PROJECT MANUAL – Book IV of IV

APPENDIX 2 – REQUESTS FOR INFORMATION (RFI) RESPONSES TO KAZONI
AND TO S.J. AMOROSO

DSH METROPOLITAN SNF BLDG REPAIR PROJECT

DGS00000142412C

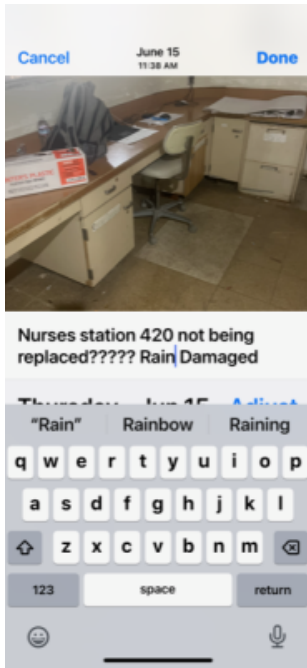
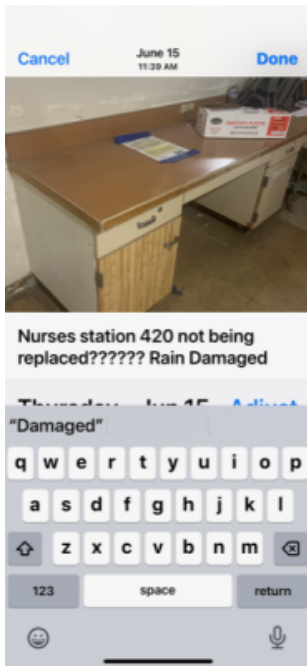
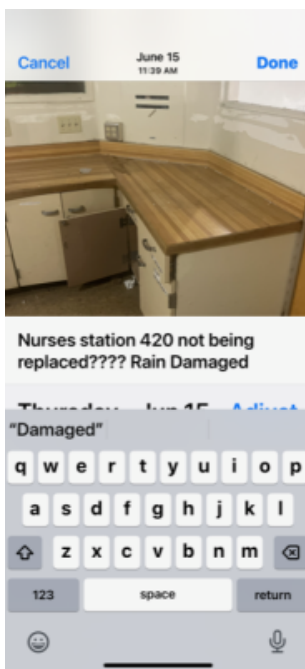
Nurses station 420 not being replaced???? RAIN DAMAGED

- 1.) Replace all millwork in nurses stations for units 417, 418 & 419.
- 2.) Replace all millwork in nurses stations for unit 420.

- 1) As indicated on sheet A4.2, A4.3 and A4.4, replace the water damaged nurse station for units 417, 418 & 419.
- 2) Replace the water damaged nurse station for units 420. Please also obtain approval from PM and DSH.

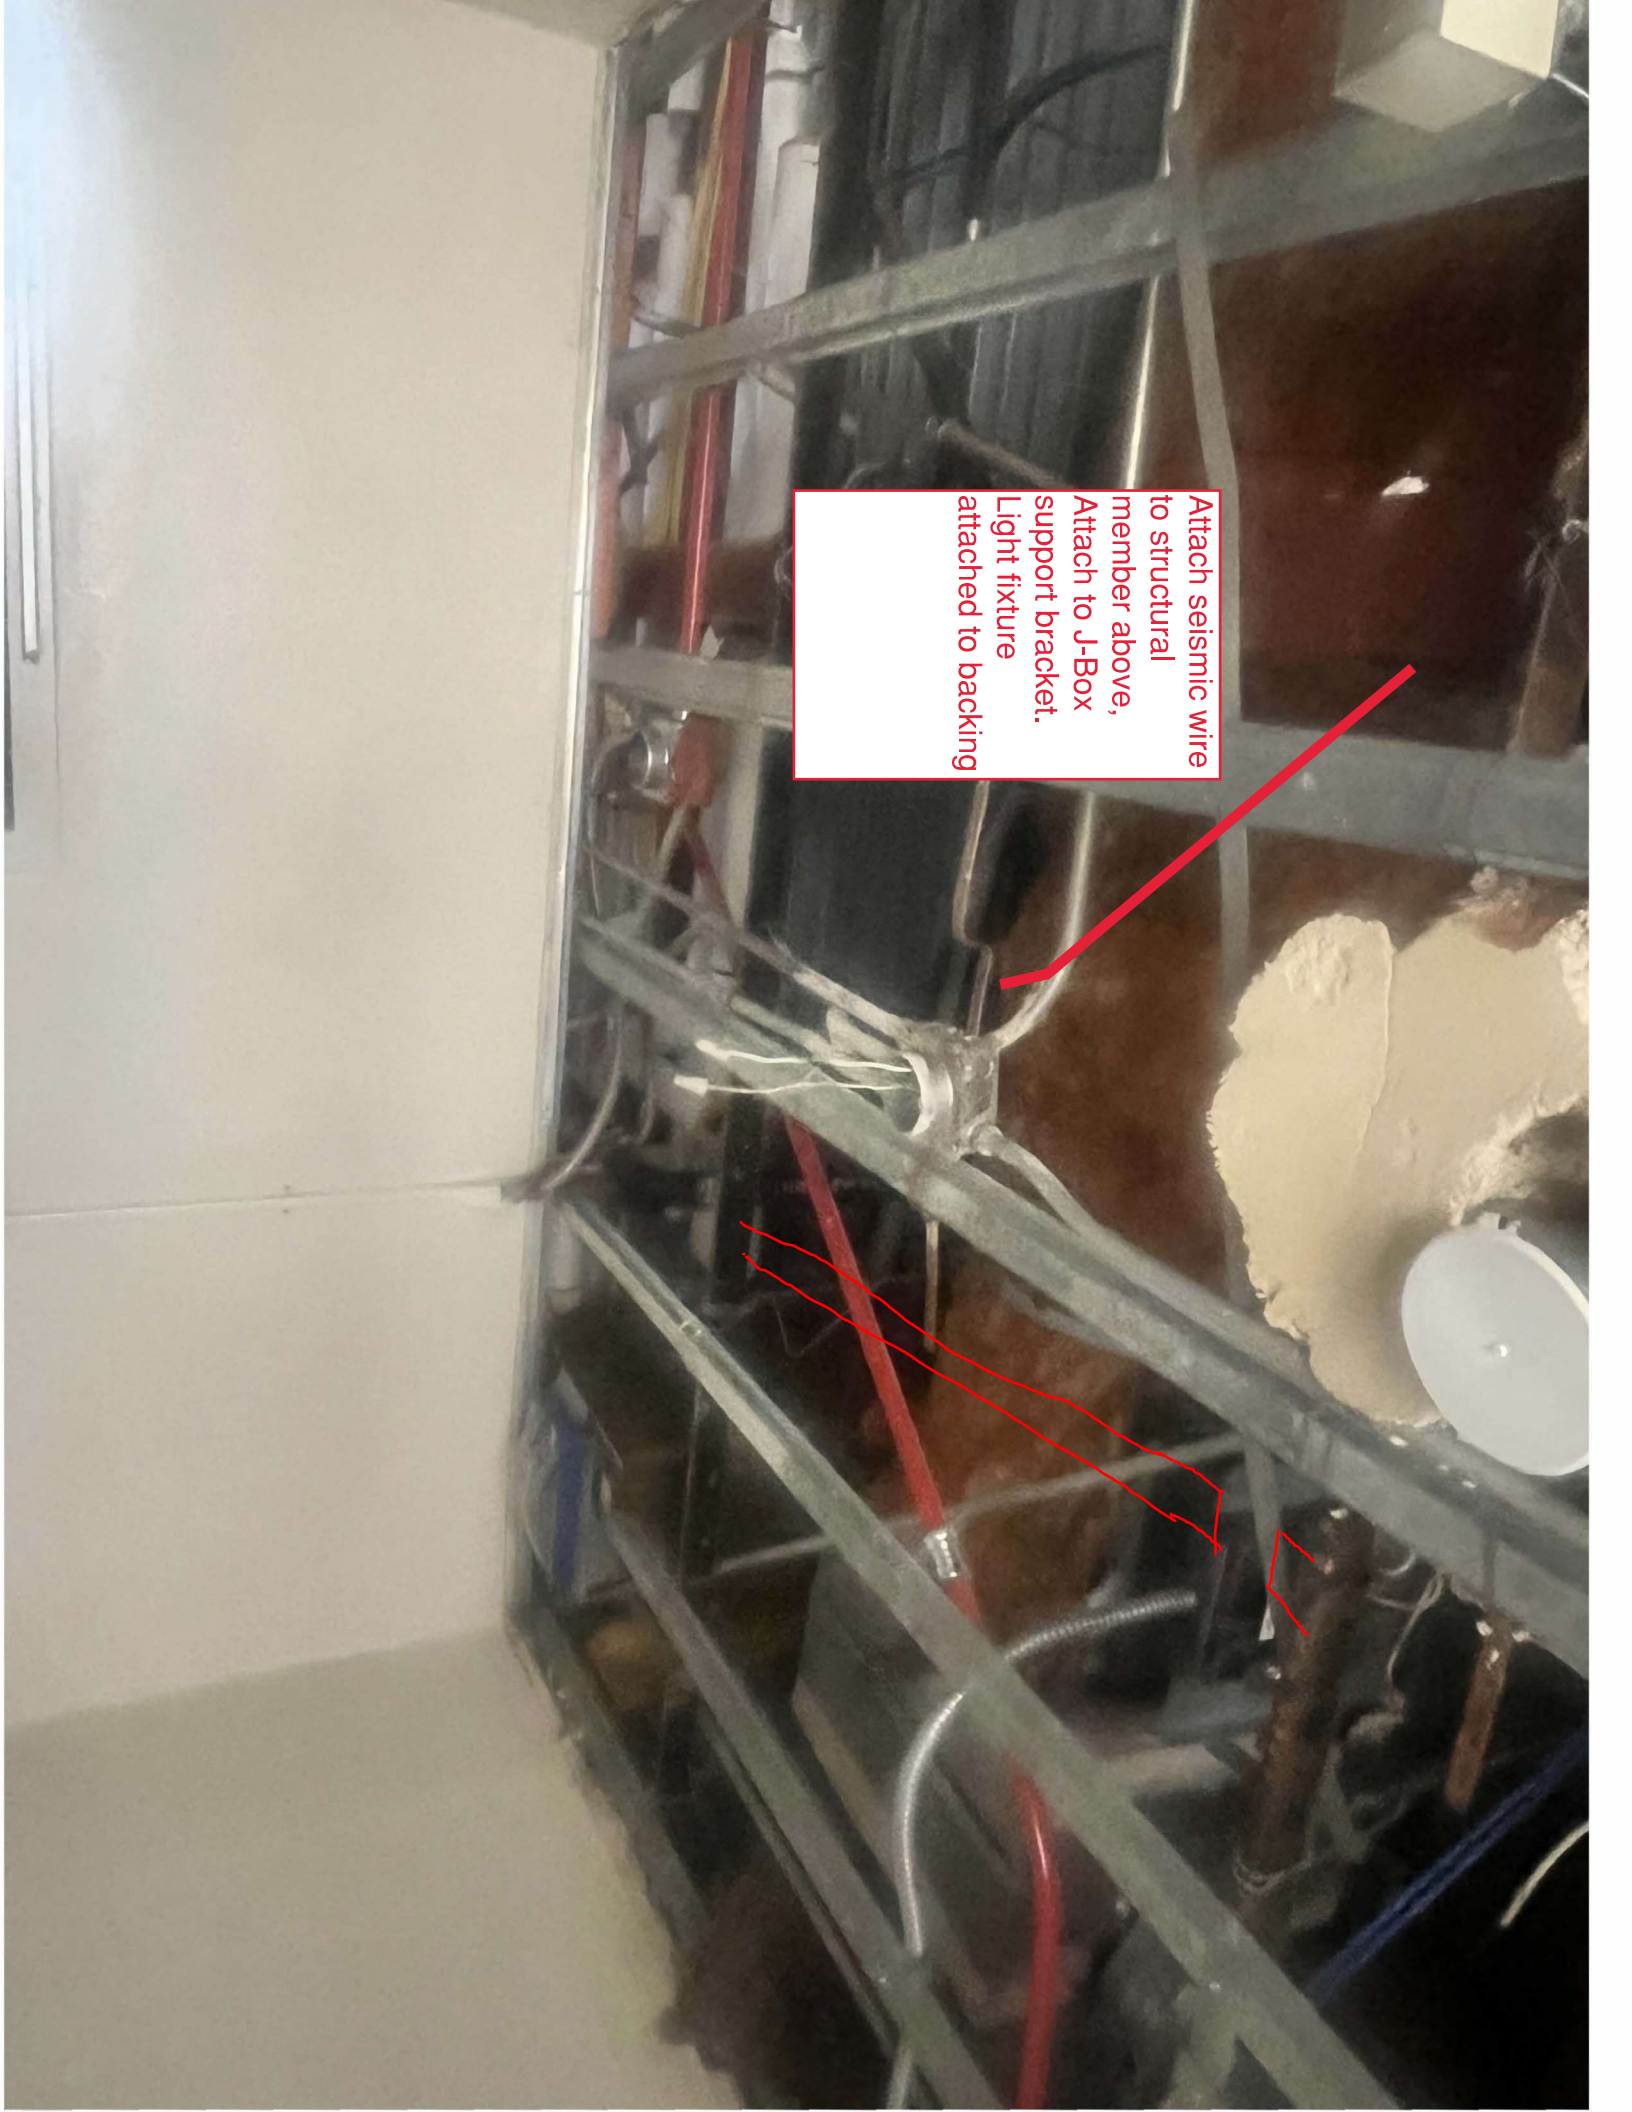
Per detail 3 on sheet A3.3, we will use the following attachment method for the seismic wires for surface mounted light fixtures at the suspended ceilings per a previous DSA approved seismic wire attachment (used on previous projects that Thomas (IOR) was a team member). A wire will be attached to a structural member up above the J-box and then attached to the bracket that the J-box is attached. The light fixture will then be secured on both ends by being screwed into the backing. (See attached photo)

Attach seismic wire
to structural
member above,
Attach to J-Box
support bracket.
Light fixture
attached to backing

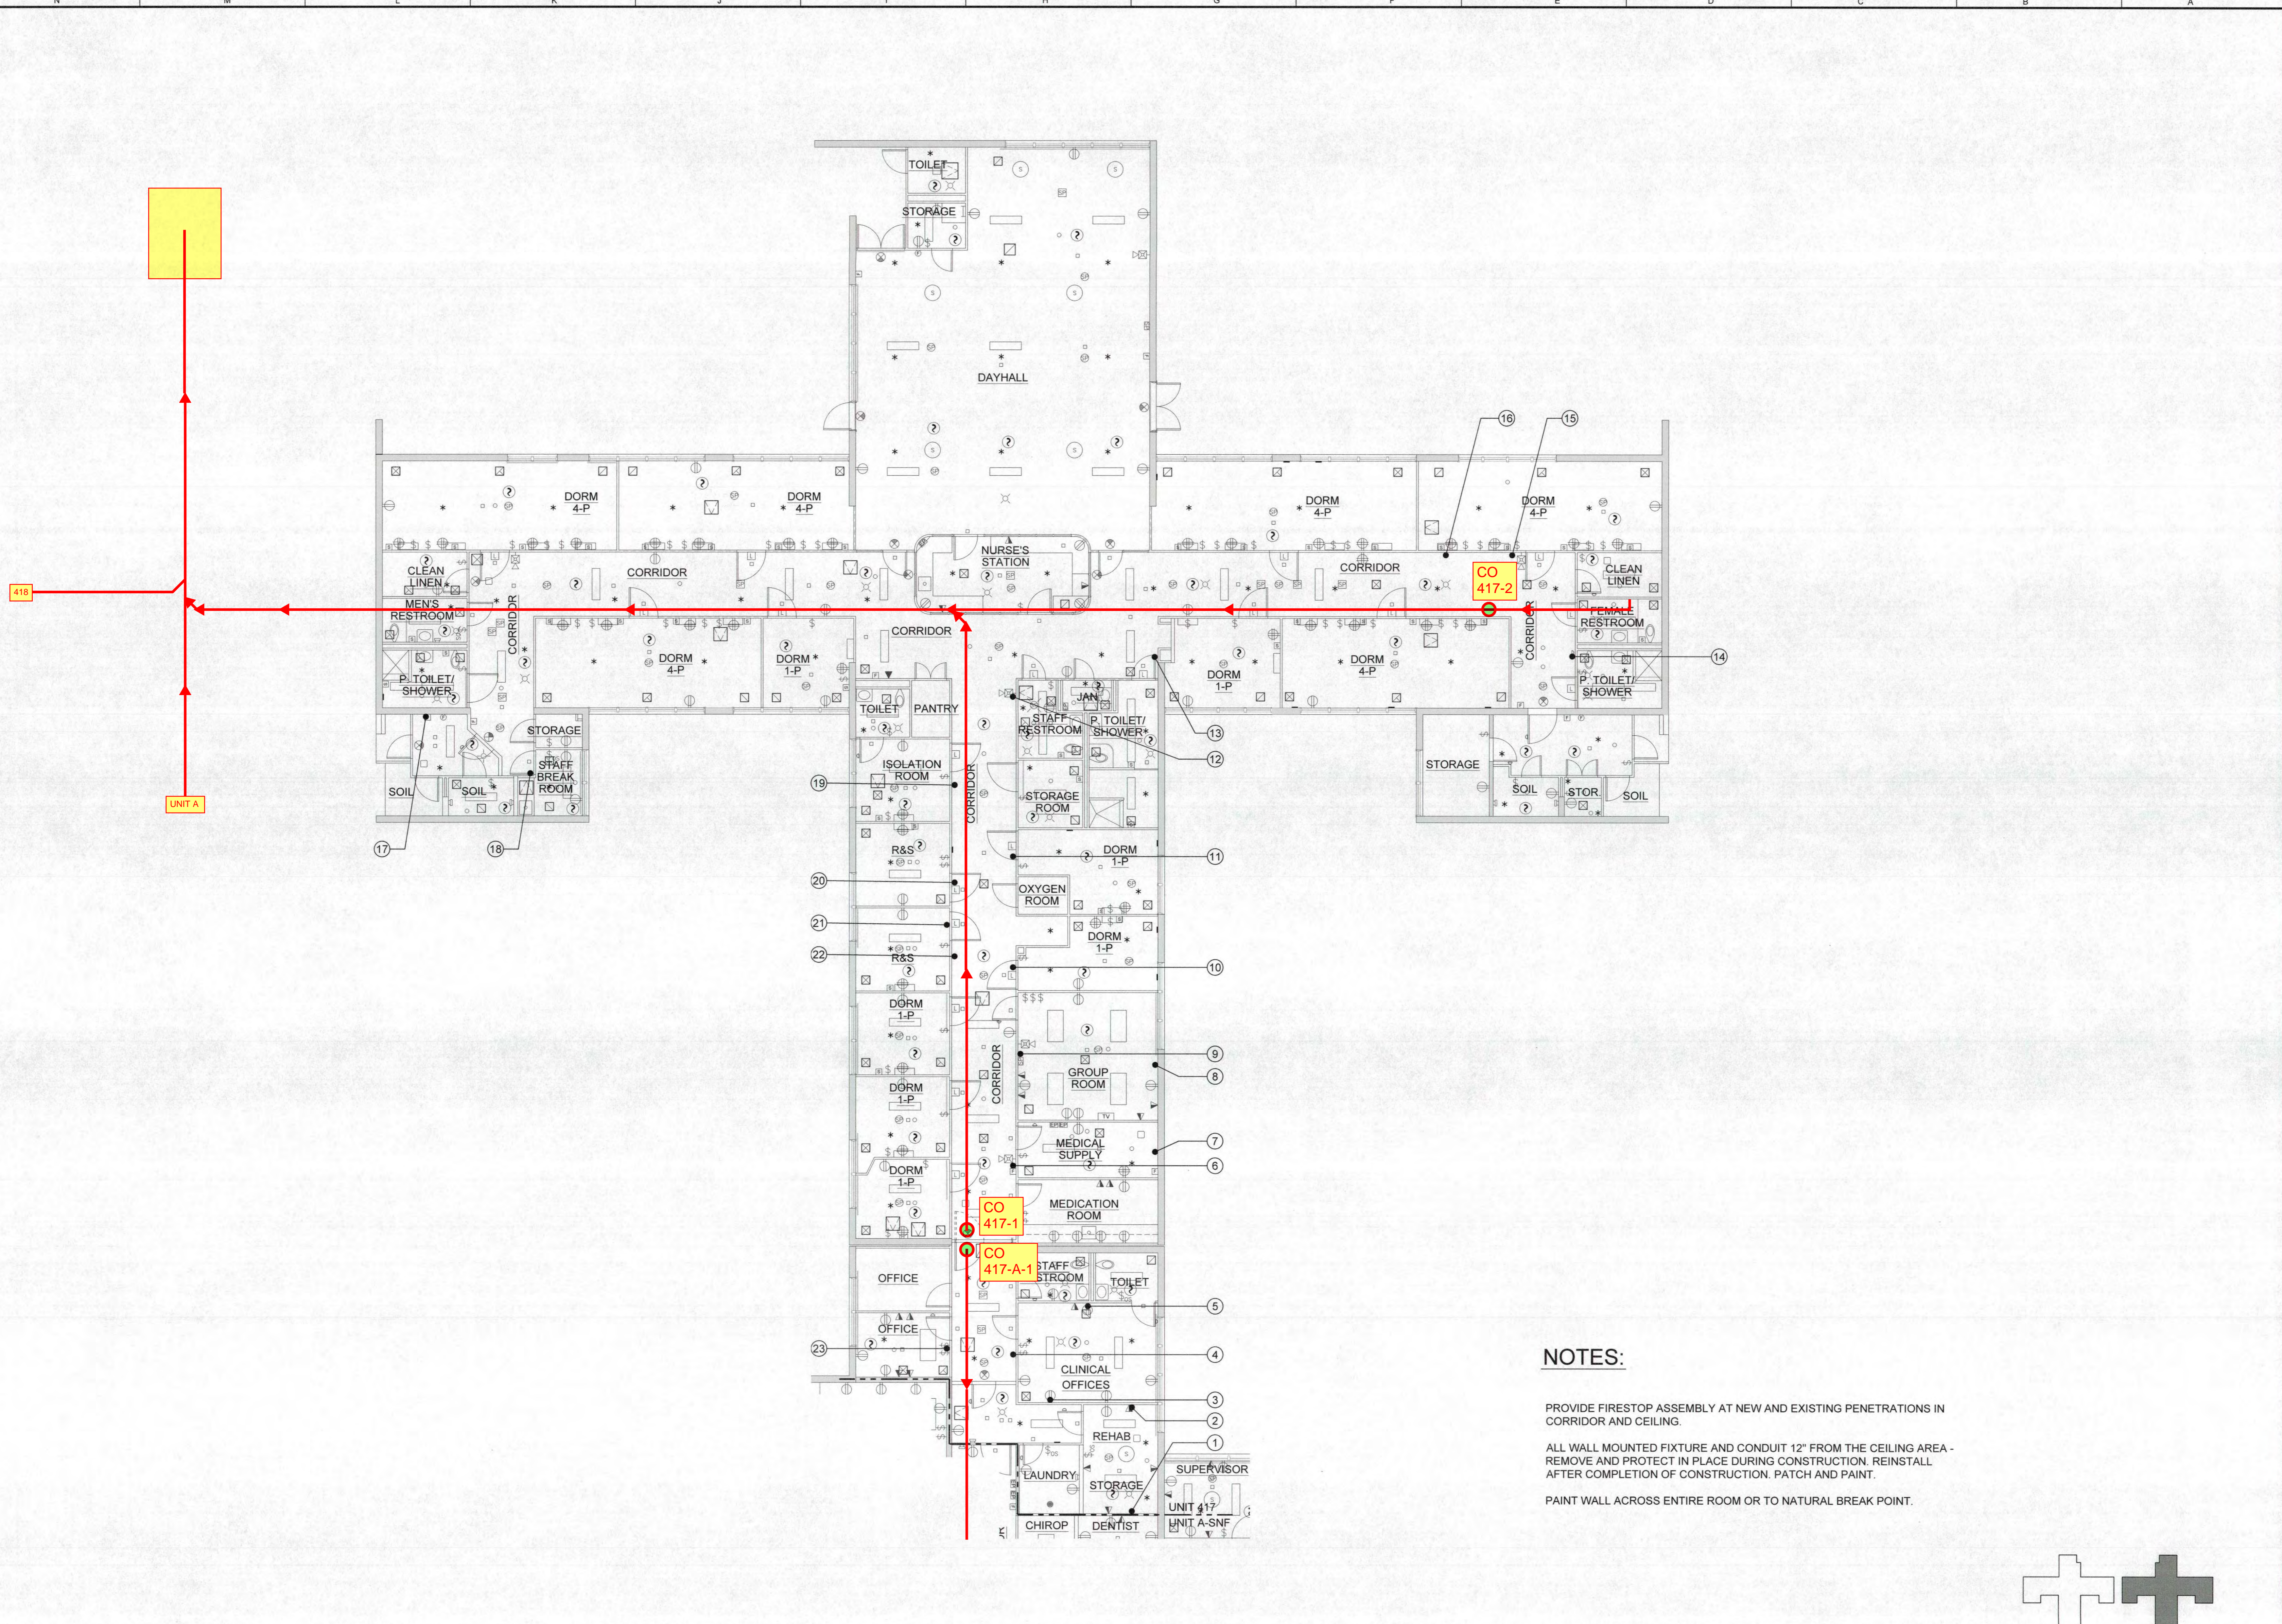
Please see attached Camerascope Markup and the link below for the recorded video per location. After camerascoping and investigating, Pan-Pacific Mechanical (plumber) recommends jetting the entire sewer system.
Please confirm this is acceptable.
Link for videos: <https://ppmechanical.egnyte.com/fl/pcykONiSWG>
